HISTORIC LANDMARK COMMISSION STAFF REPORT

**Alvord Garage
PLNHLC2011-00456
University Historic District
1158 East 400 South
September 15, 2011**

This is a request by Kathleen Hill, architect, representing property owner Michael Alvord, for approval of a new garage located at 1158 East 400 South in the University Historic District. The proposed garage will be 714 square feet. The subject property is located in the R-2 (Residential and Two Family Residential) zoning district.

**Attachment A
Site Plan**

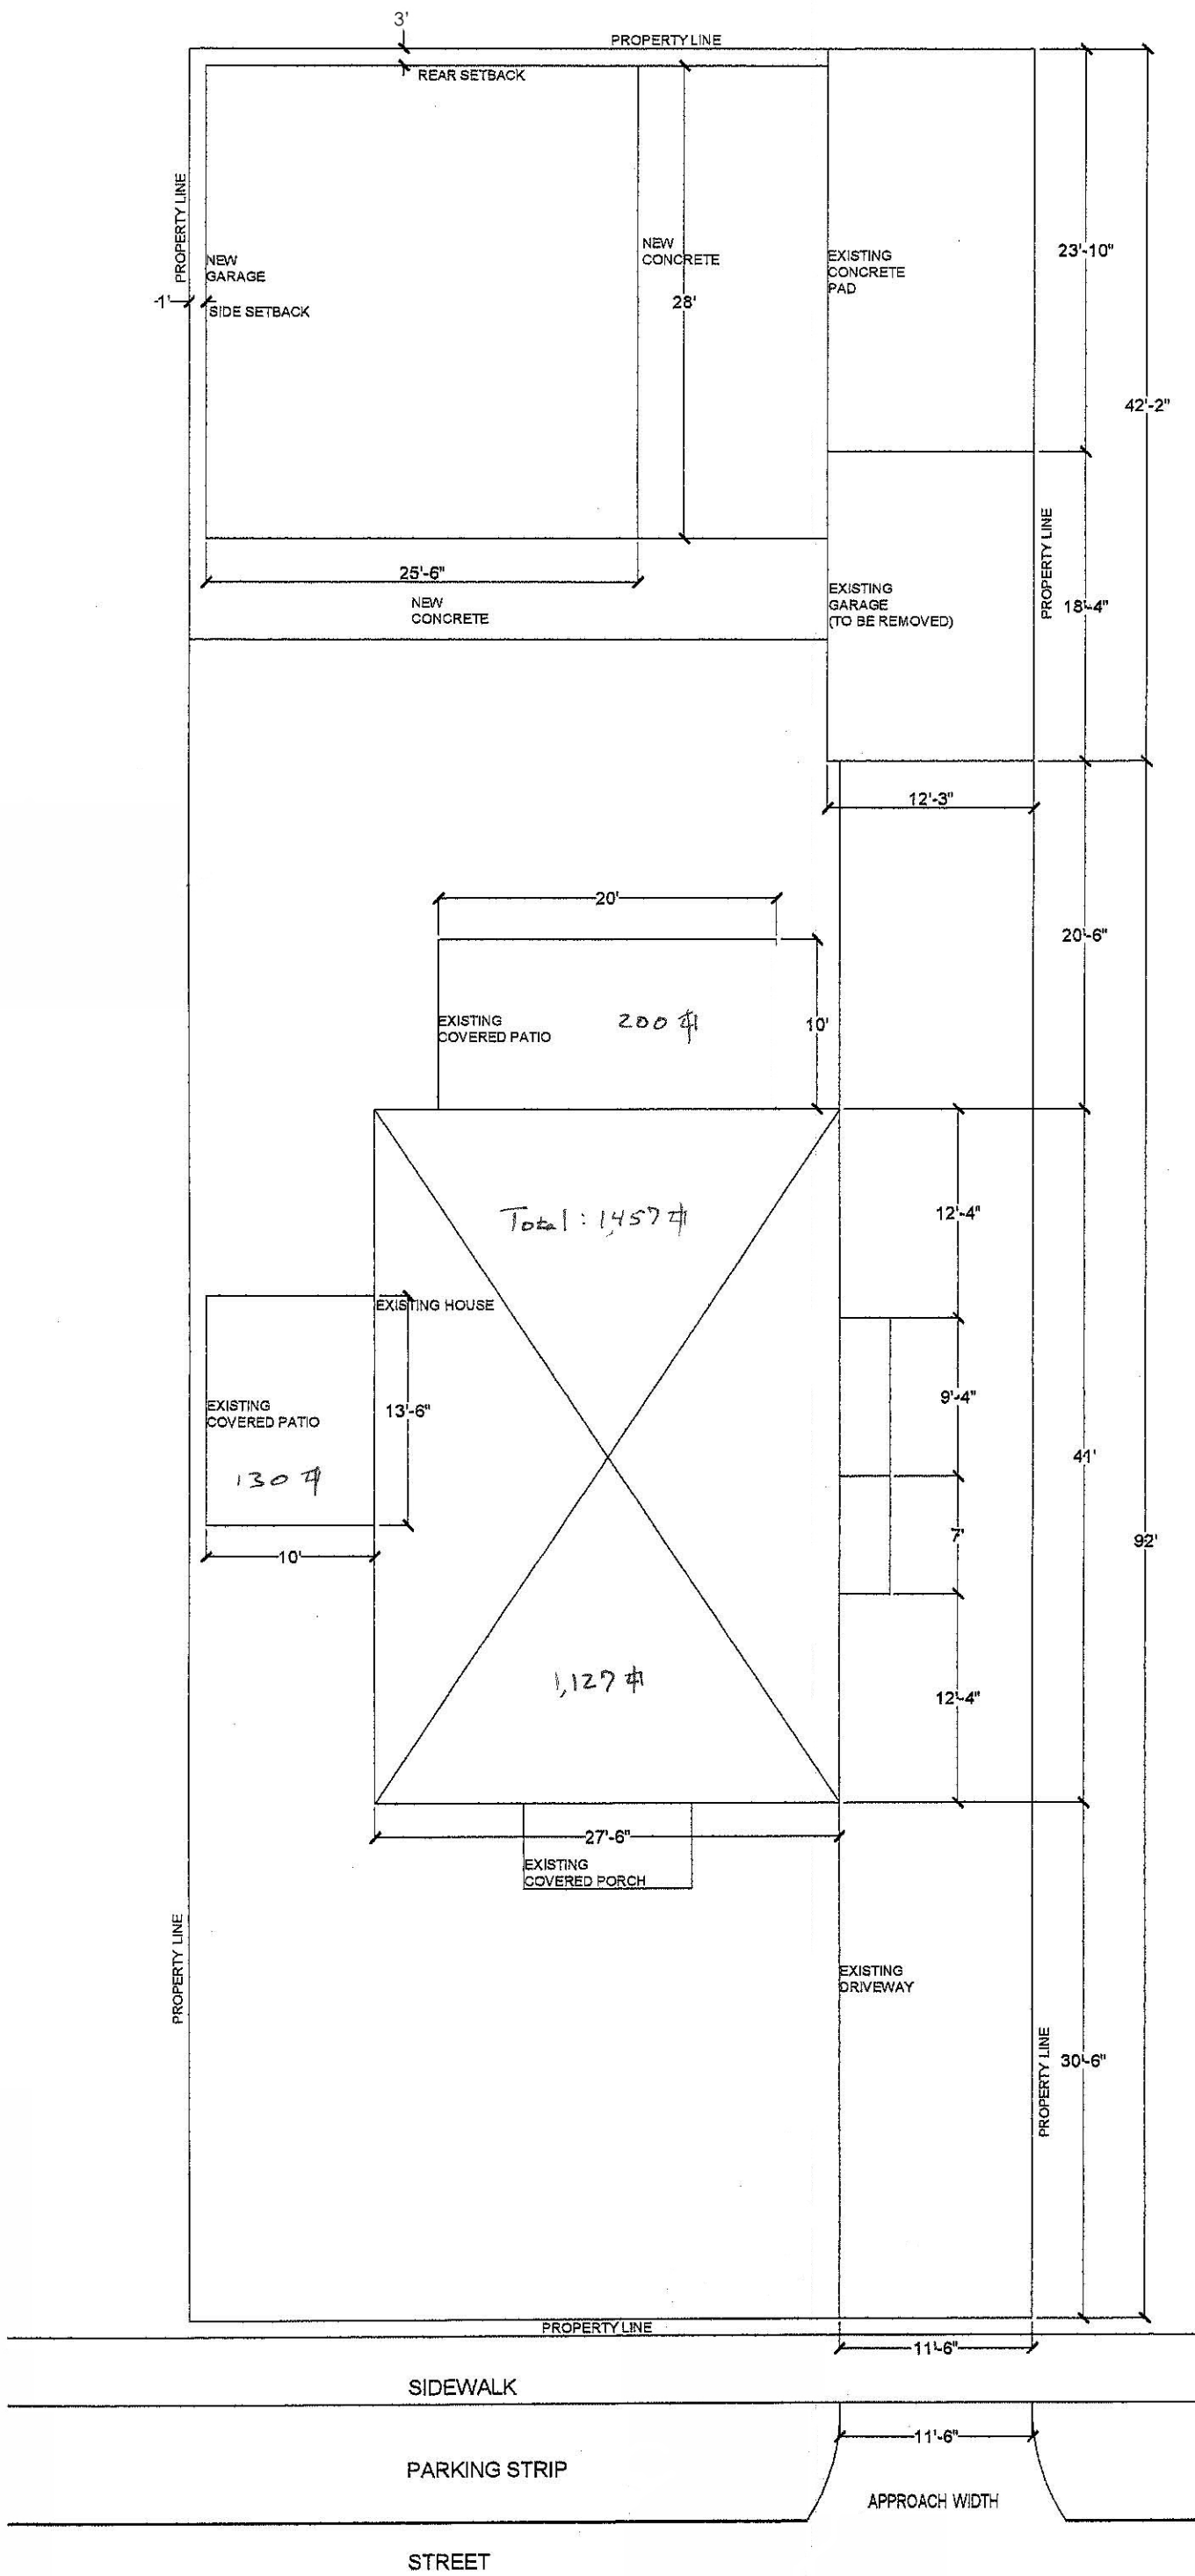
Analysis: Garages in the University Historic District are set back on the lot and are detached from the house. The proposed location for the garage is in the rear yard three feet from the rear property line. The location of the garage at the rear of the lot is in keeping with the character of the block and historic district.

Finding: The proposed project complies with the intent of this standard.

**Attachment B
Elevations**

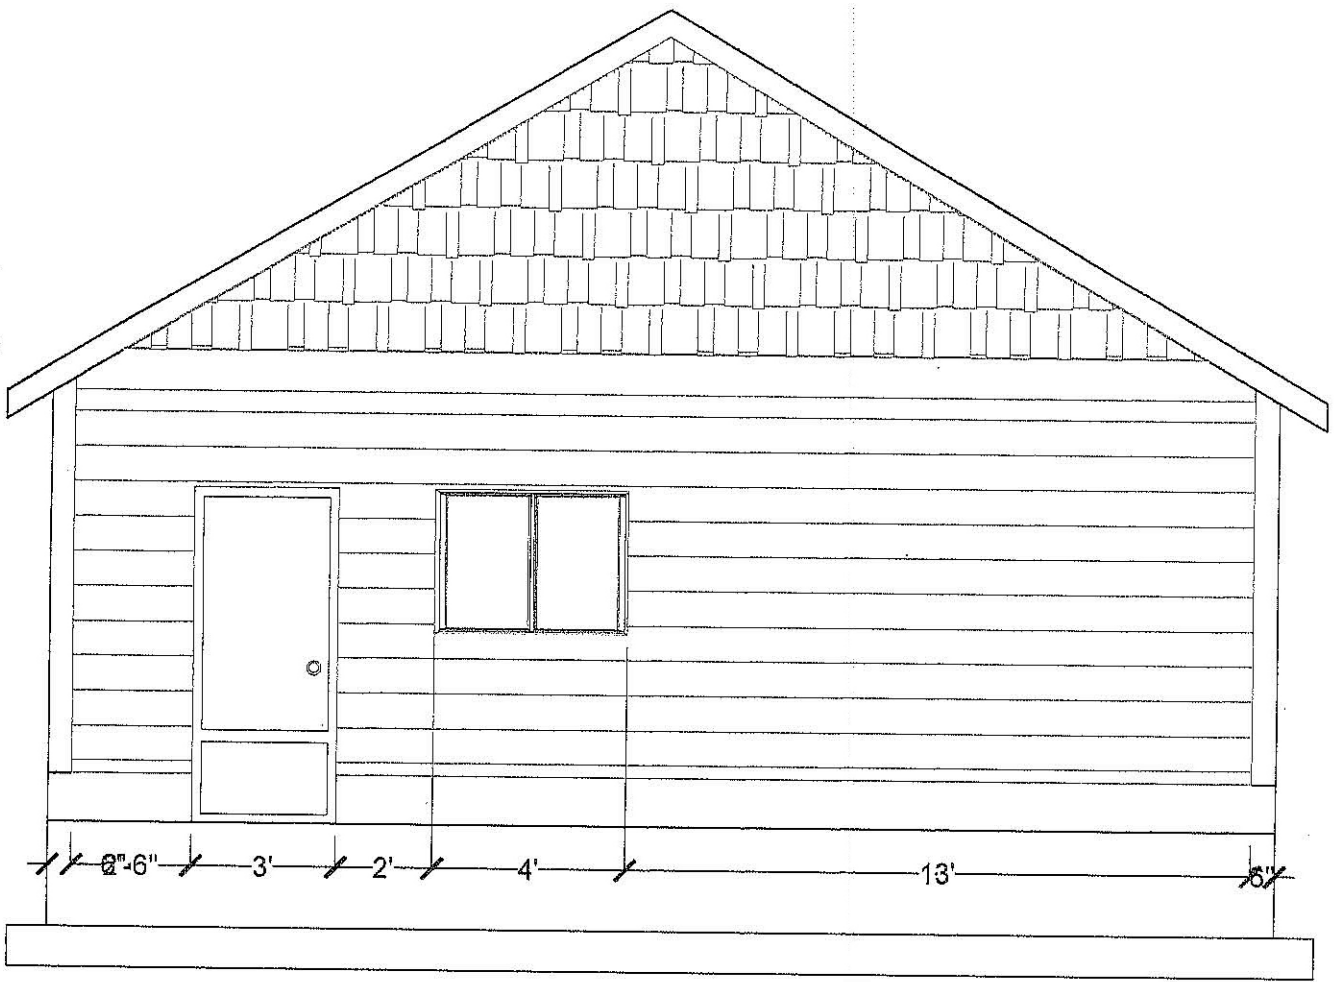
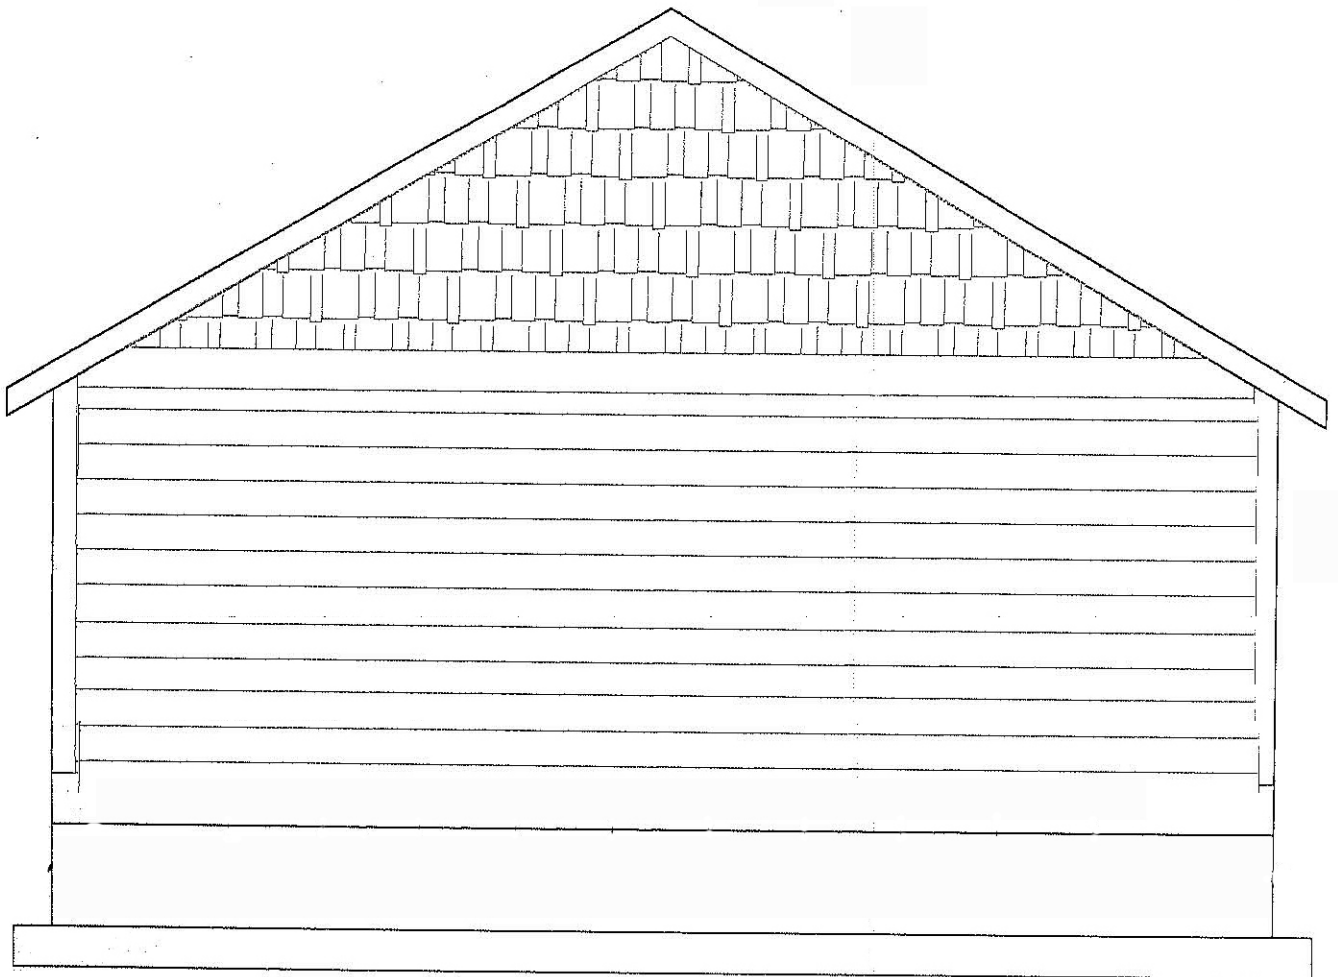
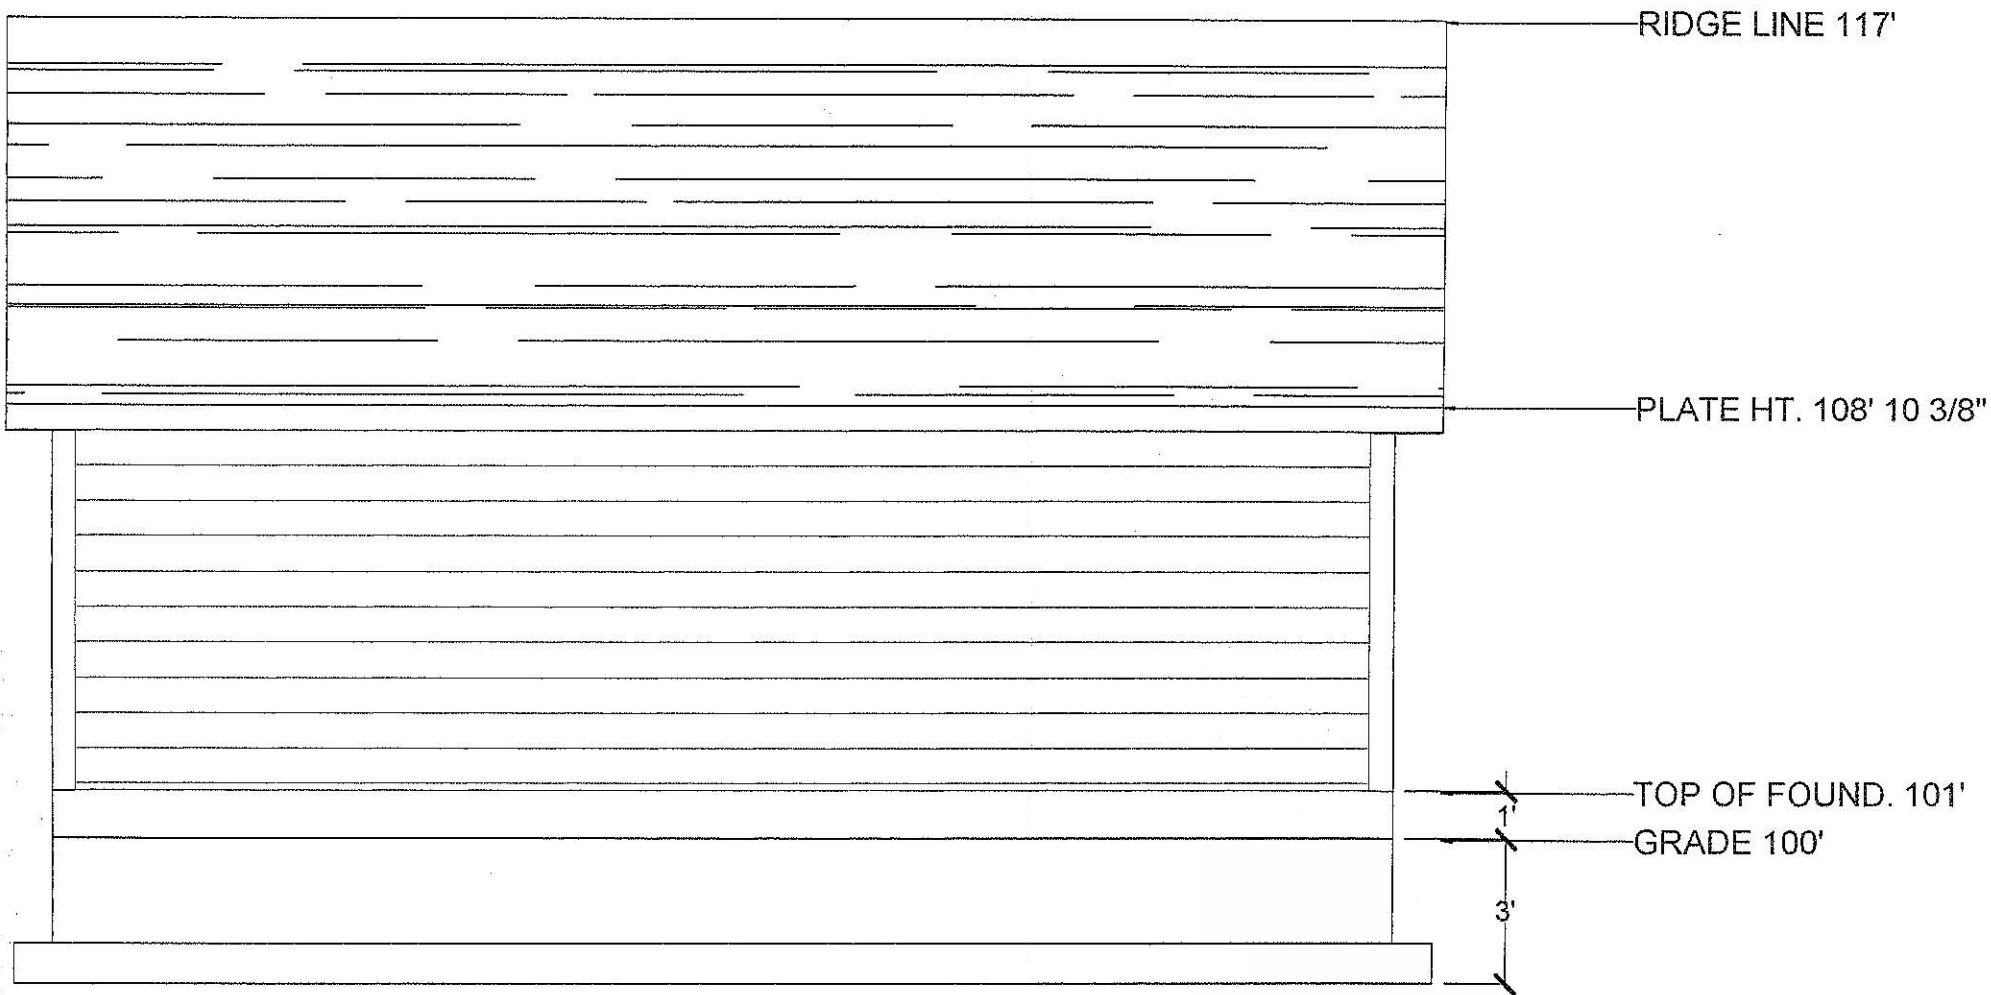
Analysis: The roof will be gabled and will mirror the roof of the principal structure. The siding will be horizontal lap. The garage will have two single doors.

Finding: The scale and form of the proposed garage is compatible with the principal building and with other garages in the University Historic District. Staff finds that the proposed garage will be subordinate to the primary structure. The project meets the intent of this standard.

Analysis: The proposed garage is compatible with the primary structure in general design and materials and its materials and form are appropriate for the neighborhood. The fiber cement is a synthetic material that has been approved by the Historic Landmark Commission many times before.

Finding: The relationship of materials is visually compatible with the materials found in the neighborhood. The project meets the intent of this standard.
